SERVICE BULLETIN

Service Bulletin No. / Date: SB TMG 651-1006 P1, Initial Issue / January 20, 2016

Subject: Turbocharger hose replacement

Type affected: All Piper PA28 with TAE 125-02-99

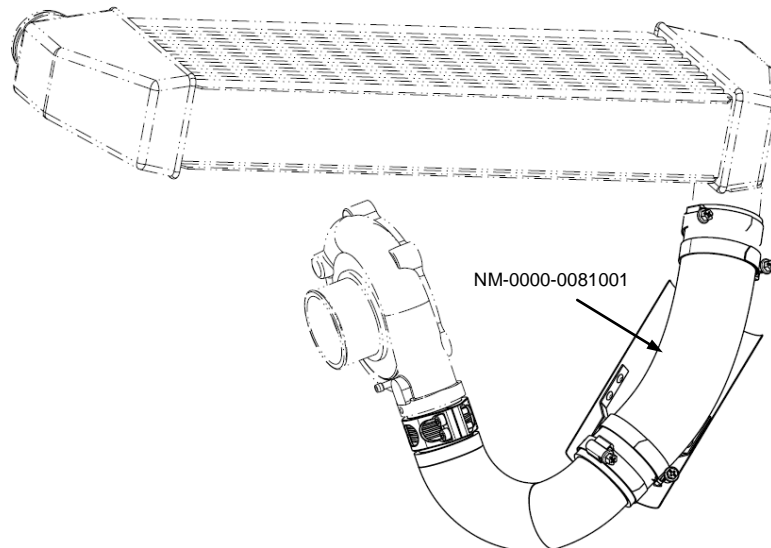
Action: Due to field failures the turbocharger hose NM-0000-0081001 should be replaced by an improved version at a maximum lifetime of 900 flight hours.

3. Installation of the turbocharger hose (NK-0000-0009701)

- If removed, install the turbo pipe and fix via turbocharger clamp. Align the turbo pipe to the intercooler port and secure the turbocharger clamp.
- Shorten the air hose (item 1.1) as required.
- Attach the air hose to the turbocharger pipe and to the intercooler port.
- Secure the hose with two hose clamps (item 1.2) on each side. Fasten also the heat protection sheet.
